I'm writing in regard to the Environmental Protection Agency (EPA)'s five-year review of the cleanup efforts at the Hudson River Polychlorinated Biphenyls (PCBs) Superfund Site. Given the serious environmental and public health risks associated with PCB contamination, thorough assessment of progress to date and what remains to be done, and how best to do it, is essential.

I am writing to express my support for a robust, thorough and detailed 5-year review of the Hudson River PCB remediation effort. As you know, this review is required by the Superfund lawⁱ in order to evaluate the implementation and performance of a cleanup plan, such as the Hudson River dredging effort, to ensure that it protects human health and the environment. Given the importance of the Hudson PCB cleanup, it is imperative that this 5-year review is not undermined by an impractical and compressed timeframe.

However, we remain troubled that the Hudson's first 5-Year Review will be limited in scope and fails to allot the time customary for this process, especially in regards to document review and stakeholder participation. Given the scope and complexity of the Remedy and the ongoing issues raised by an array

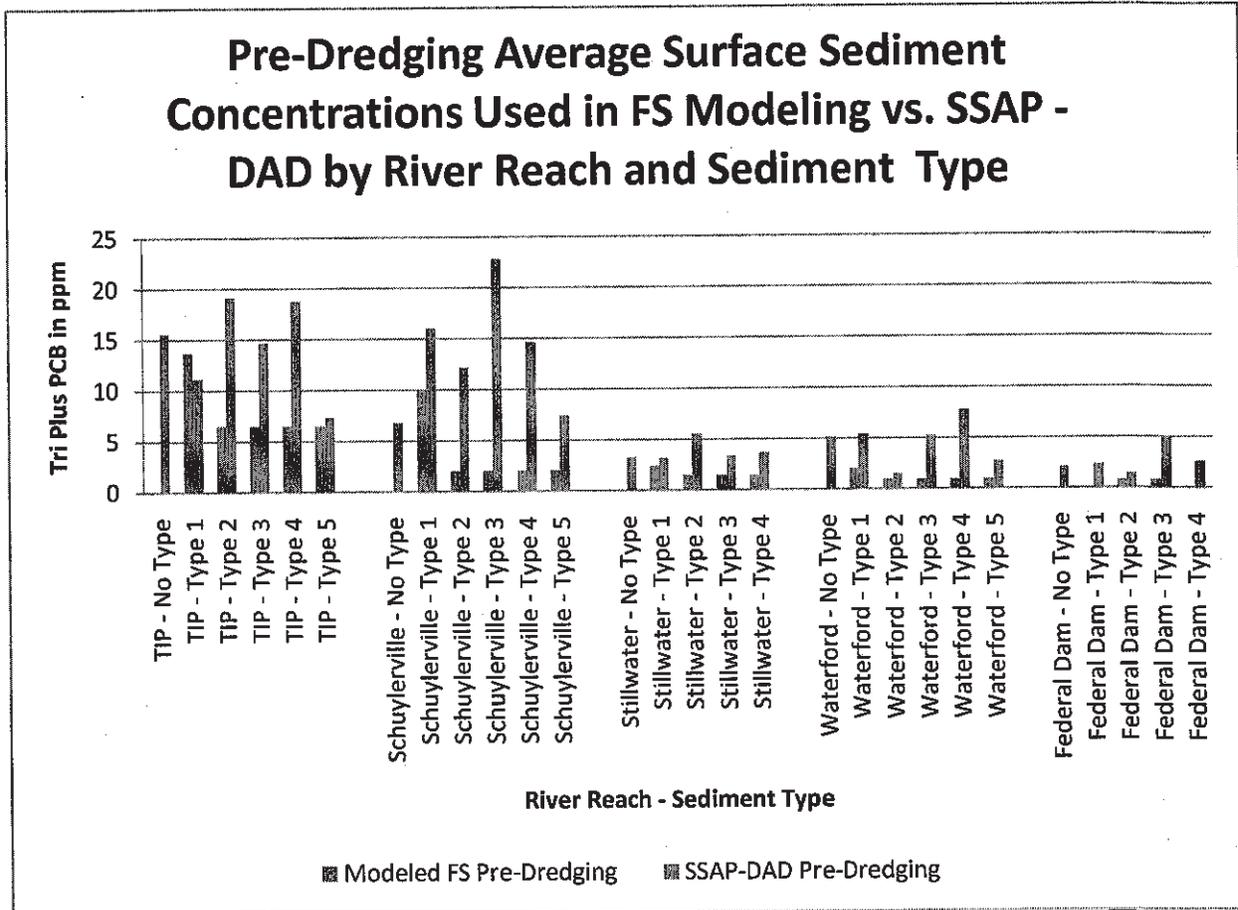
- Average surface PCB contamination in River Sections 2 and 3 are 5-10 times greater and sediment natural recovery is much slower (verging on negligible) than what was believed when the ROD was originally issued in 2002 (Figure 1).
- Average surface (maximum in top 12 inches) PCB concentrations in River Sections 1 and 2 are equally elevated (>100 ppm total PCBs), but the surface clean up trigger in River Sections 2 and 3 (~90 ppm) is about 3 times higher than in River Section 1 (~30 ppm total PCBs).
- Given these facts, following remedy implementation, approximately 5 times higher concentrations of bioavailable PCBs will be left behind in surface sediments in River Sections 2 and 3 than the ROD envisioned in 2002 (Figure 2). This should translate into a proportional

- To our knowledge, none of these points are disputed by EPA. NOAA suggests that EPA conduct an analysis on the impacts of these findings on changes to risk to fish, wildlife or humans relative to the risks originally projected by the 2002 remedy, and an evaluation of the potential need for a change in the scope of the remedy. GE's untested model seems to be the only basis for EPA to believe that fish concentrations will achieve target levels in the time frame envisioned by the ROD, rather than a more protracted time frame.

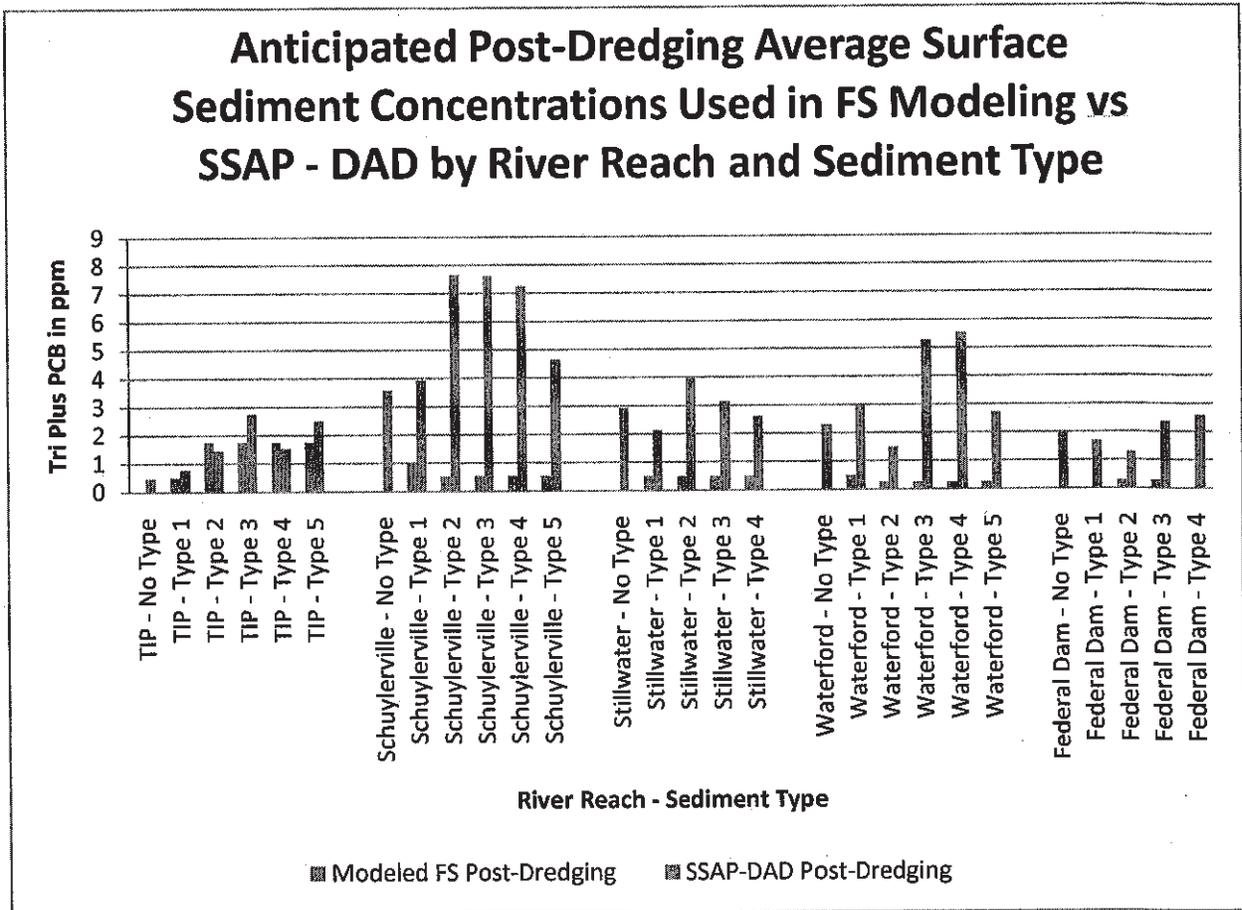
increase in fish tissue PCBs and a delay in the projected recovery of the river and the natural resources services that the river supports. There is no evidence to suggest that Hudson River fish will behave differently from the theoretical response.

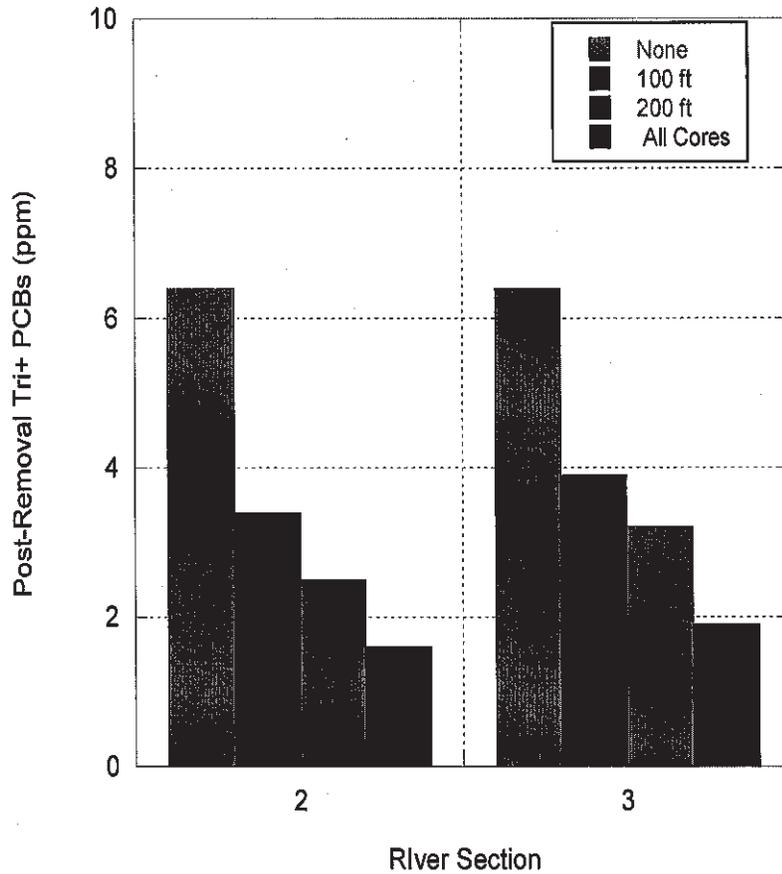
prisms. NOAA strongly recommends additional removal of highly contaminated sediments especially within 100 to 200 feet of the dredge lines (Figure 3; Figures distributed at meeting not transmitted). This enhancement to the design would result in the additional removal of 80-100 acres (15-18 % increase in sediment volume) (Tables 1 and 2) and is within the volume of sediment removal envisioned in the original ROD. Our recommendation of a uniform surface criterion across all three River Sections would significantly reduce bioavailable PCBs.
